Northfield Heritage Preservation Commission Project Plan Review

**501 & 503 & 505 Division St South Northfield MN 55057**

**Exterior Color Project Narrative**

Re: Reunion Project  
Rehabilitation of 501, 503 and 505 Division Street South  
Northfield, Rice County  
SHPO Number: 2018-2373

**501 - 505 Division Street storefront, including 503 recessed door detail by Medin Architects plans, A5.0, as of 10.3.2018**

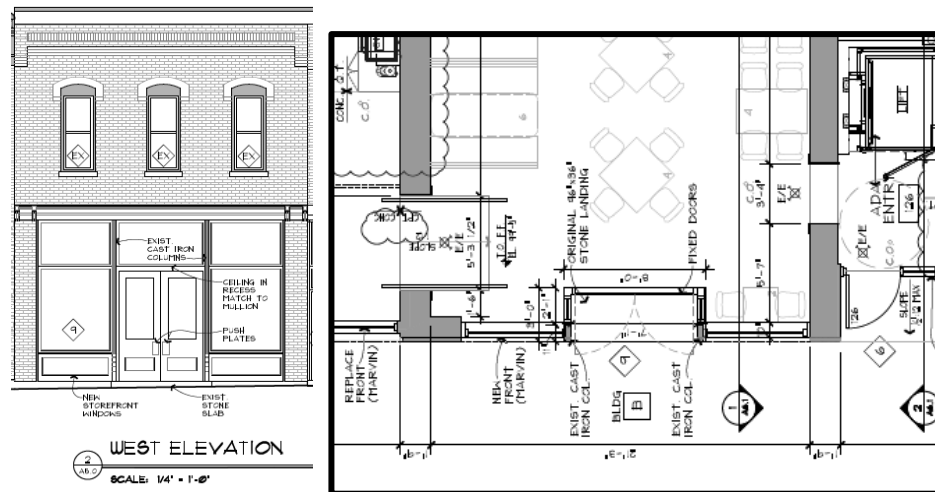
1. Change to 503 Division Street South storefront layout to add doors and alcove windows
2. Change to 505 Division Street South storefront cornice
3. Exterior color selections

**505 Division storefront photo from 1900's; winter 2017/2018; Color Illustration presented to Northfield HPC in May 2018**

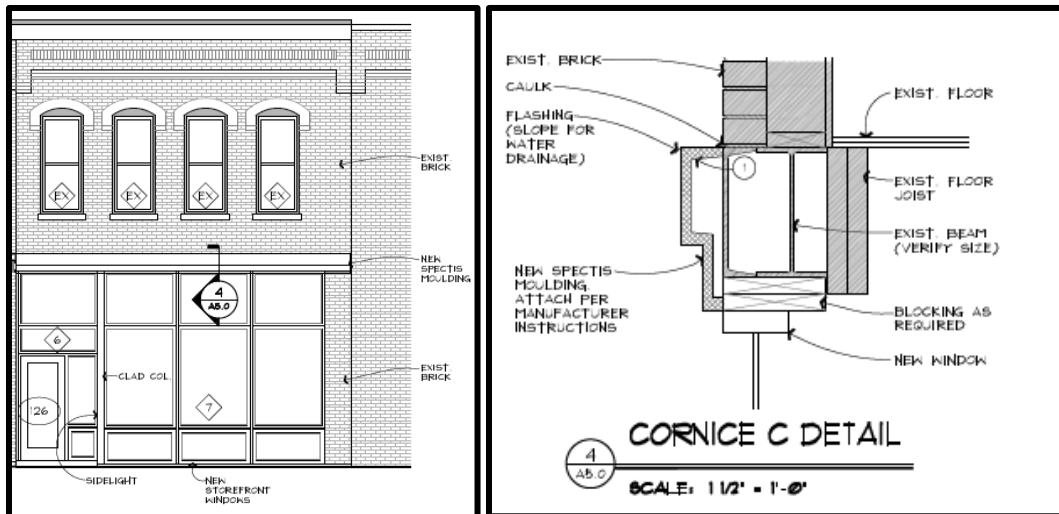
After further review of our project by the MN State Historic Preservation Office, it was determined that this building shall have a muted cornice design. No evidence can be found of this building having cornice detail as shown in our previous plans, and in fact comparable buildings (3<sup>rd</sup> and 4<sup>th</sup> in from corner buildings) in the Northfield Commercial Historic District have very simple storefront cornices.

- New storefront cornice to be a simple, flat trim piece as evidence of detailed trim does not exist
